Office Action Summary

10/656,824

RICHARDS, WILLIAM R.

The specific fuel cell stack modules attached to the receiving areas can be observed from viewing **Figure 1**:

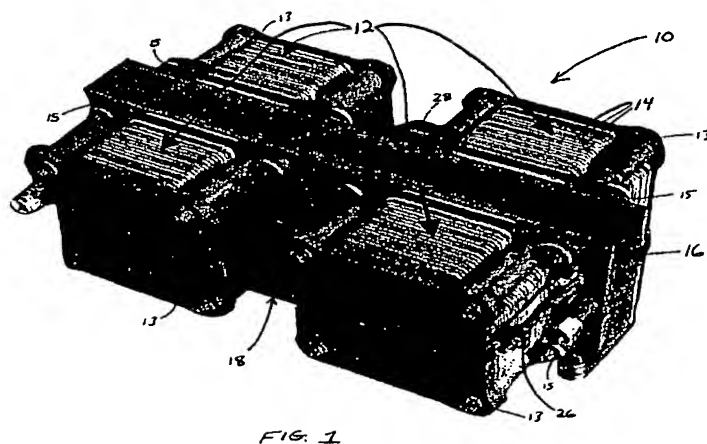
Disclosed is the presence of stack cap 13 and a stack footprint 15 sandwiching the electrochemical cells (P. 0021). *Thus, the stack cap and the stack foot print act as the end plates.* It is disclosed that an alternate embodiment has the footprints electrically disposed to the manifold 16. Each stack 12 is electrically conductive, and has a top terminal electrically connected to its cap 13; and a bottom terminal 28 electrically connected to its footprint 15. (P. 0021). *Thus, all fuel cell stack modules are electrically connected to their end plates as well as to the base of the receiving areas.*

Mukerjee et al further disclose that, generally, the system may comprise at least one fuel cell assembly in combination with respective control valves and a multiplicity of sensors and actuators (P. 0020). *Hence, it is noted that Mukerjee et al readily envision and provide specific guidance to positively employ control valves and actuators, singly or collectively, in the fuel cell system as ancillary equipment for supporting the operation thereof. Since the claimed valves and actuators do not indicate any further structural limitation or spatial orientation other than being “apparently” connected to the supply ports and accommodated in the fuel cell modules, it is contended that the teachings of Mukerjee et al directly envisage the use of such components (i.e. valves and actuators) as part of the flow distribution system.*

FIG. 2

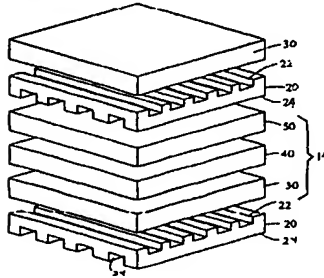
Figure 2 shows interconnects 20 disposed adjacent to the electrochemical cell and comprising passageways 22 to carry fuel to the anode from the inlet port at the port assembly; and passageways 24 carrying oxygen to the cathode which is thereby disposed in fluid communication to an air inlet port at the port assembly 18 (P. 0023/ Figure 2). *It is noted that*

interconnect are also known in the art as providing the same function of a bipolar separating plate.

Fig. 4

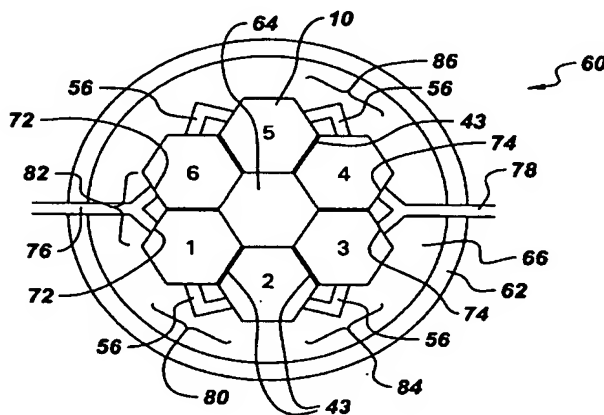
Figure 4 below illustrates planar fuel cell having an hexagonal shape (P.0022) and fuel feed line 76 and fuel exhaust line 78 (P.0034); and inner volume 64 allowing passing of air introduced at oxidant inlet 68 (P.0028).

Bourgeois et al disclose that each planar fuel cell unit is polygonal. Beneficially, polygonal configurations of fuel cell units are relatively easy to manufacture and permit minimal yet robust sealing arrangement and sufficient resistance to the reactant flow through the stack;

and self-alignment of the fuel cell units due to the angles provided by the polygonal shape (P. 0022).

Examiner's note: *it is averred that such a polygonal shape of the fuel cell units produces substantially the same effect of specifically claimed module tapering configuration and taper angle. That is to say, the specific polygonal shape of the fuel cell units necessarily accommodates the cells so as to wedge them together by the polygonal tapering sides.*
